HERBAL HOUSE

Planning Amendments - Minor Material Amendments Document

25th January 2017

863 - Herbal House - Outline Schedule of Changes

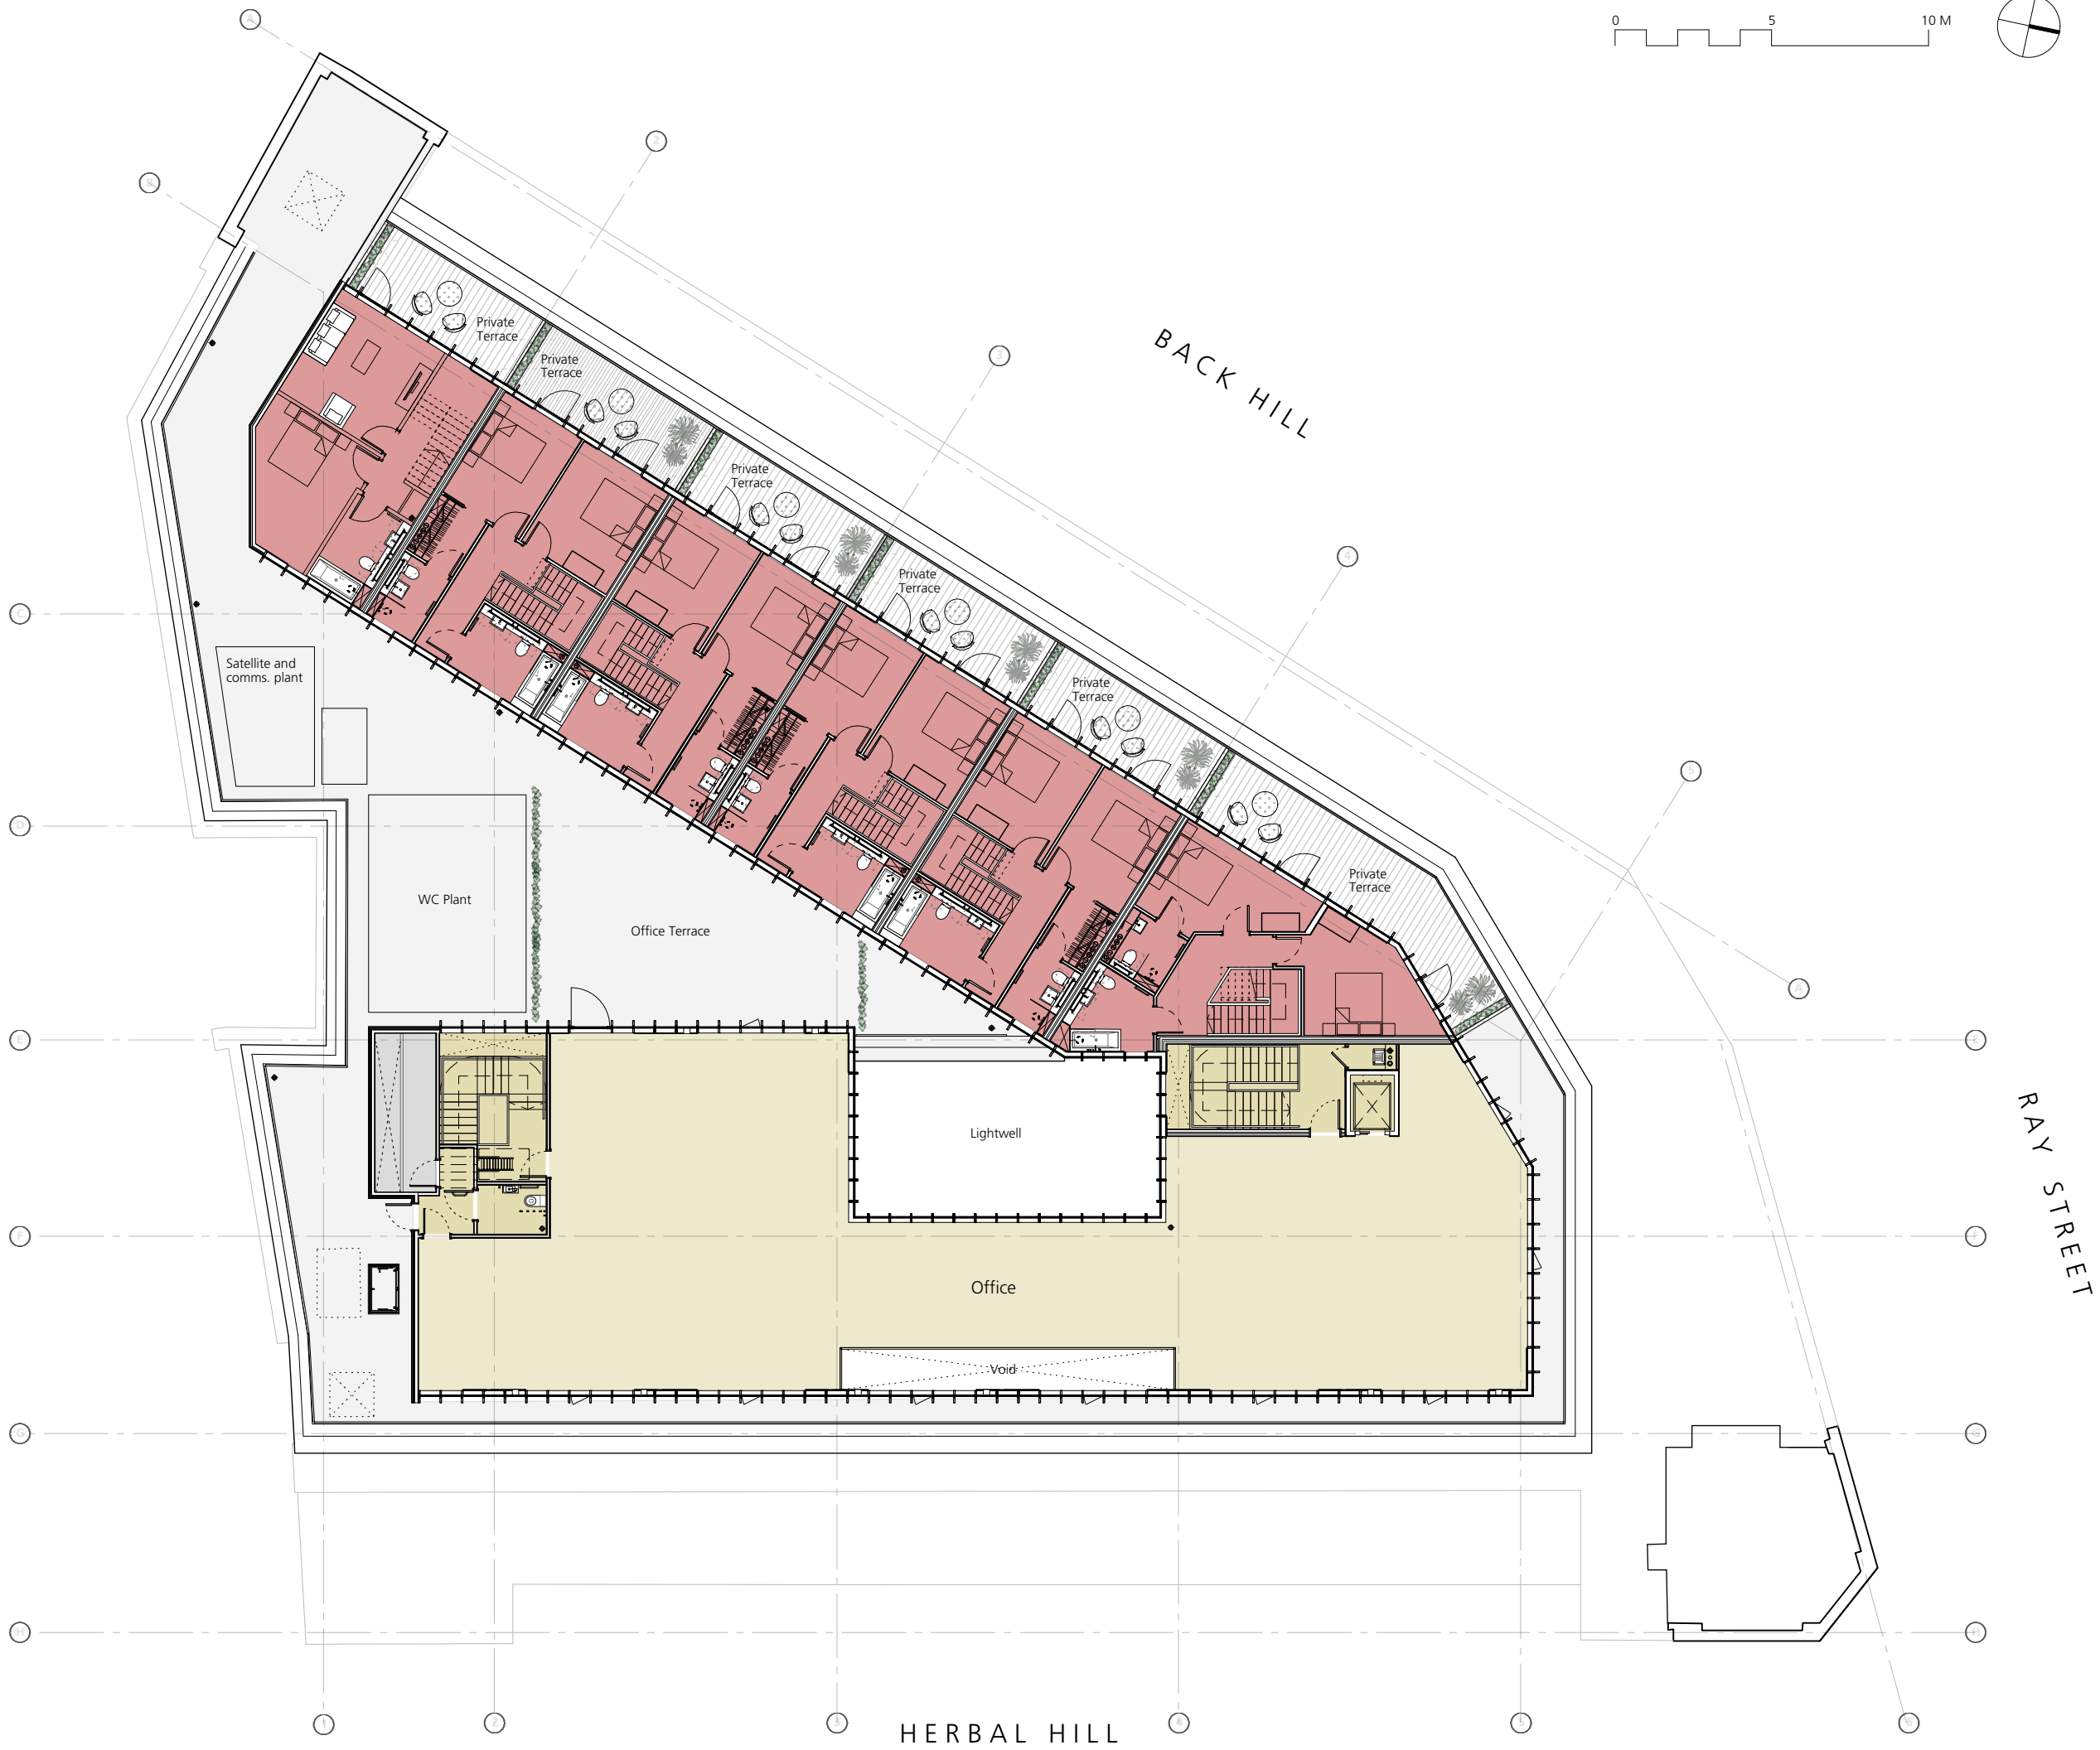
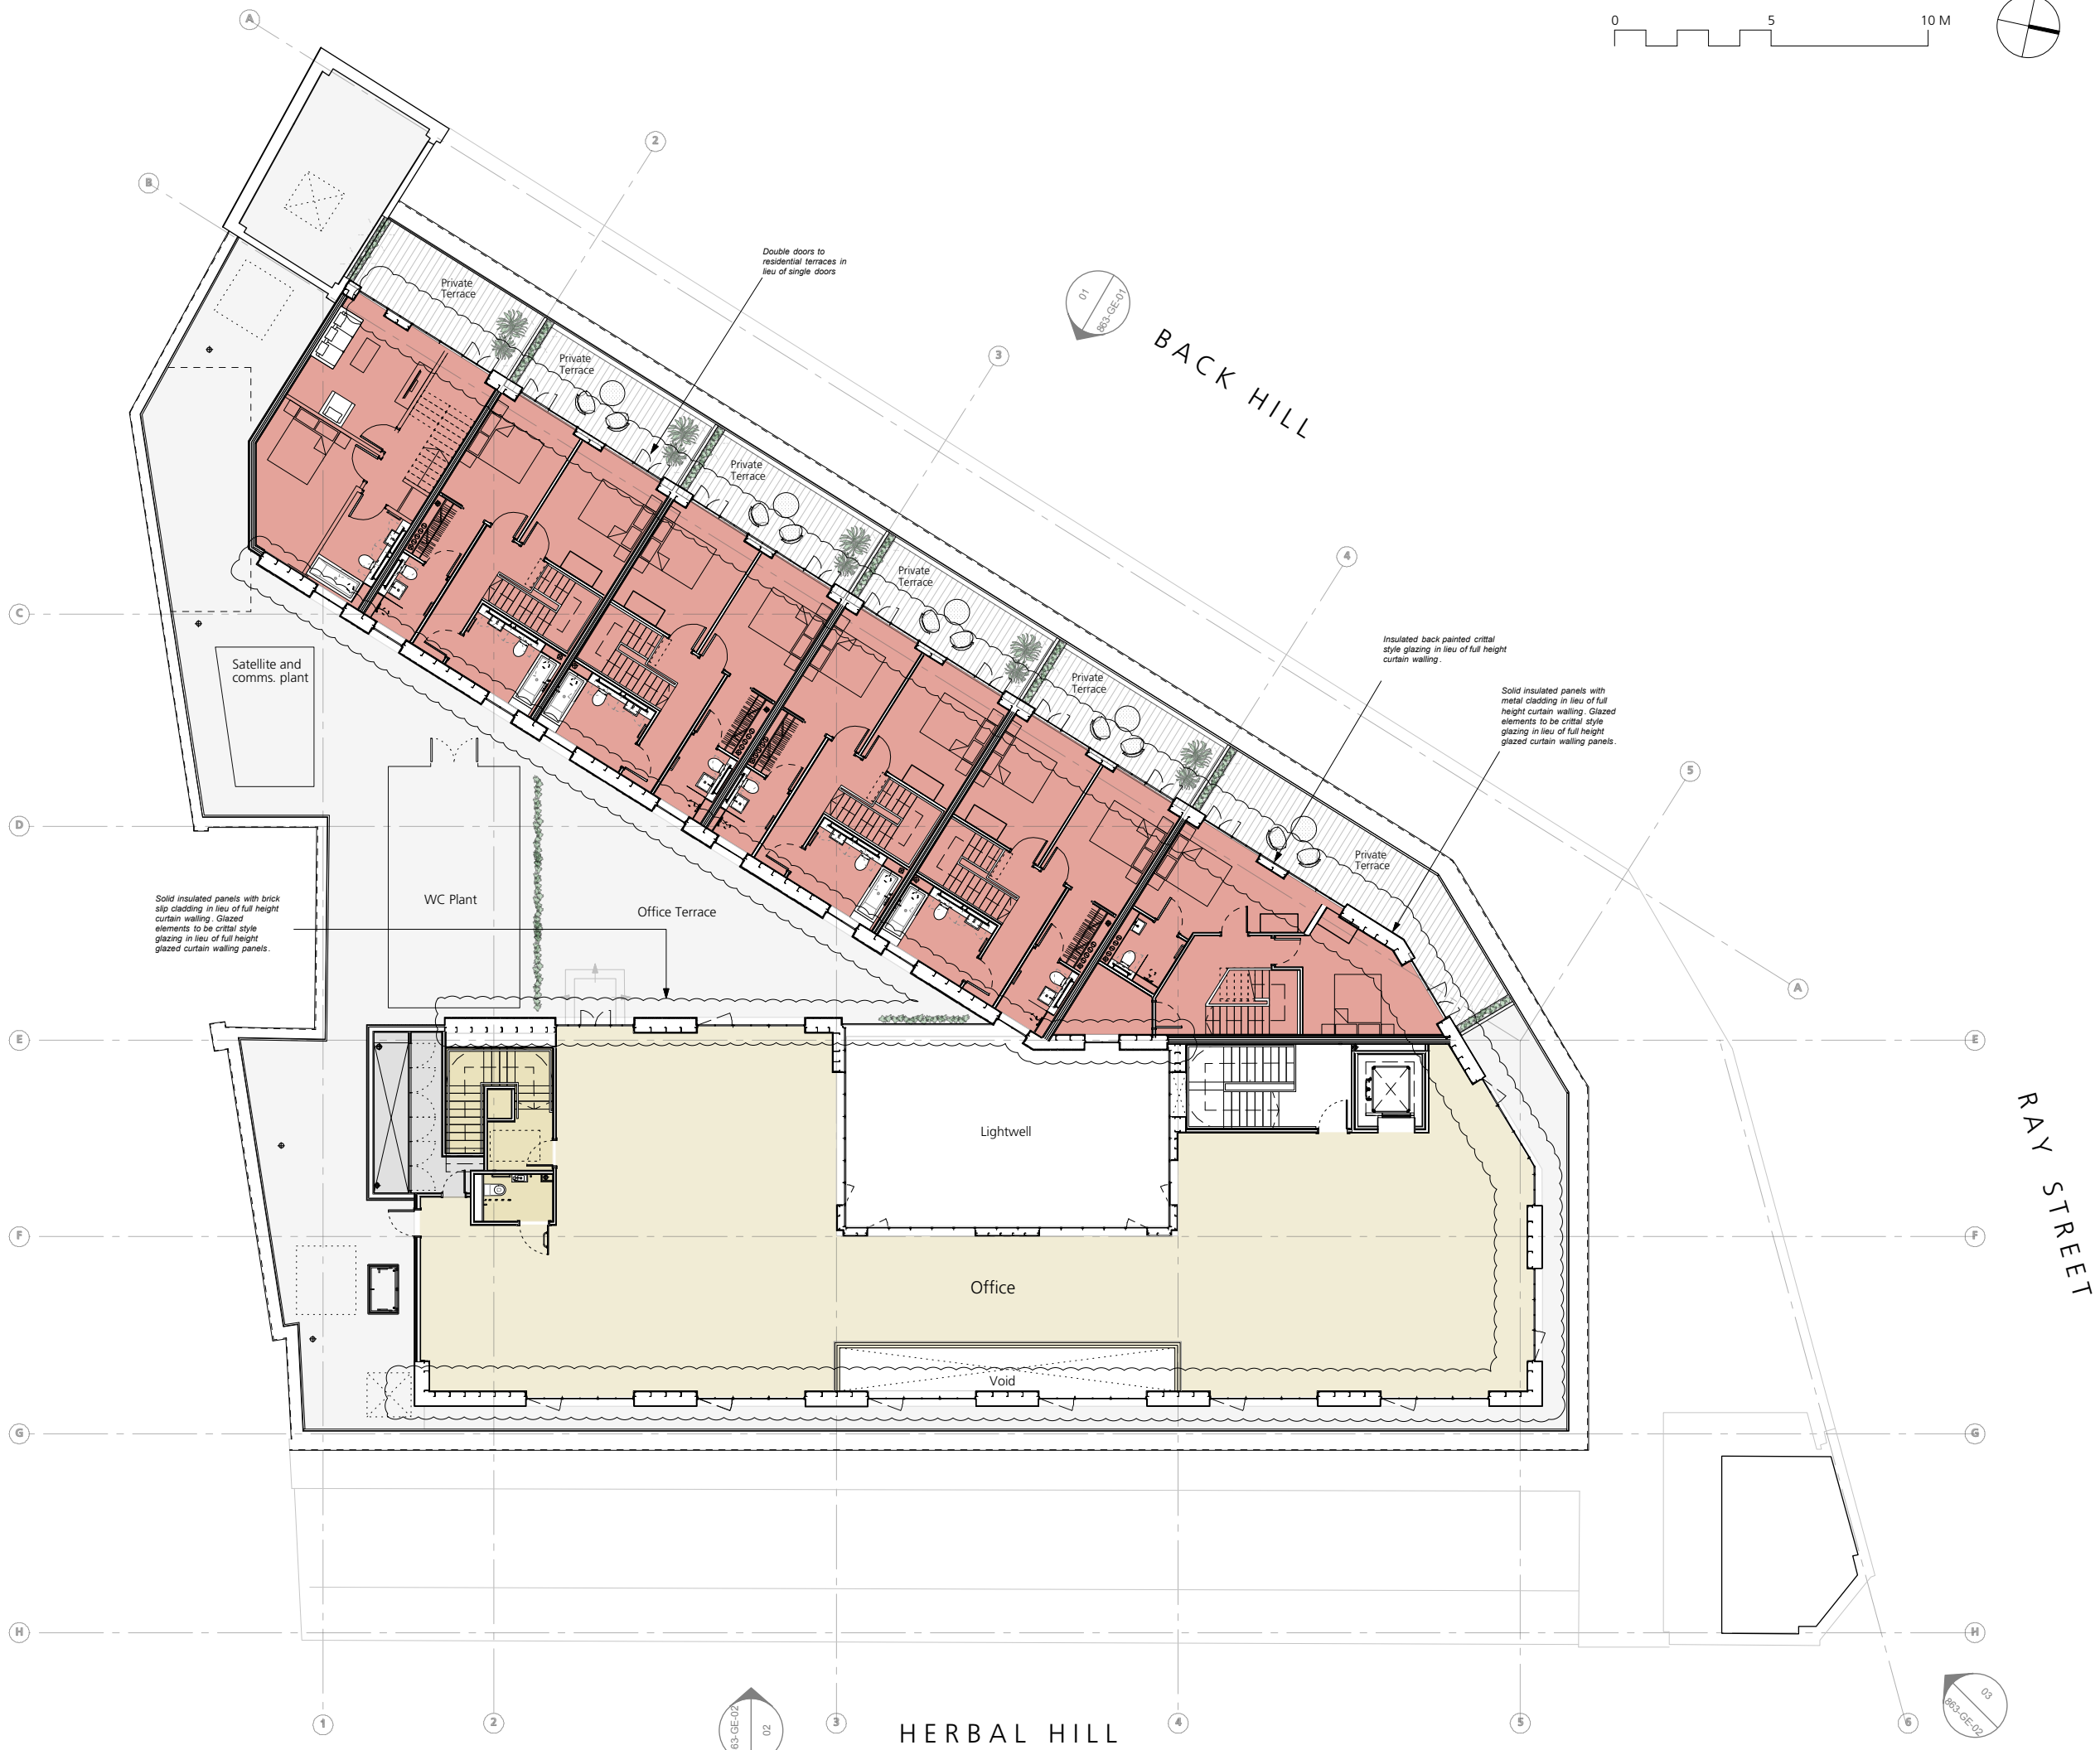
Original Scheme	Revised Scheme
DRAWINGS			
		(863_GA_05, 863_GA_06, 863_GE_01, 863_GE_02)	
Elevations			
(863_PL_GE_01, GE_02)	1.01	Back painted glazed curtain walling to solid elements of 5th and 6th floor extension	Metal cladding to insulated panels to solid elements of 5th and 6th floor extension
	1.02	Full height glazed curtain walling panels to 5th and 6th floor extension	Crittall style glazing to 5th and 6th floor extension
	1.03	n/a	New insulated back painted crittall style glazing
	1.04	Single doors out to residential terraces	Double doors out to residential terraces

Approved Scheme,
as Amended by
2015/3337/P

Amended Scheme

P6	Planning amendments - MMA	20/01/17
P5	Planning amendments - MMA	18/05/16
P4	Planning amendments	24/04/15
P3	Planning - Office terrace removed	31/10/14
P2	Planning - Unit layouts	07/07/14
REVISION		DATE
Buckley Gray Yeoman		
Studio 4.04 The Tea Building 56 Shoreditch High Street London E1 6U T: 020 7033 9913 F: 020 7033 9914		
CLIENT	Allied London	
PROJECT	Herbal House	
DRAWING	Sixth Floor Proposed	
SCALE	1:100 @ A1 (1:200 @ A3)	
DATE	01.12.13	DRAWN BY OB
DWG No:	863-PL-GA-06	REVISION P6
DRAWING STATUS	Planning
